September 27, 2019

Version 2

Product Update: Display Audio Clock Off by 1 HourSupersedes 19-096, dated August 29, 2019, to revise the information highlighted in **yellow**.**AFFECTED VEHICLES**

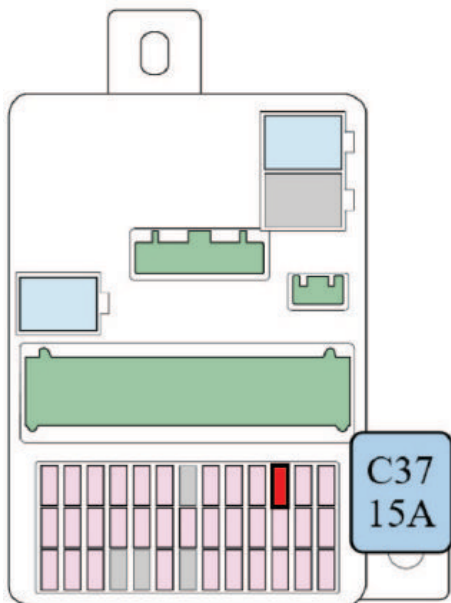
- If **B.1.0.26** or higher is displayed, go to step 6.
 - If **B.1.0.26** or higher is not displayed, contact Tech Line.
- Turn the vehicle OFF and** pull the 15 amp B+ radio fuse for **10 minutes** to clear the data from the audio unit.

If this step is skipped or not correctly done, the customer will still experience the issue.
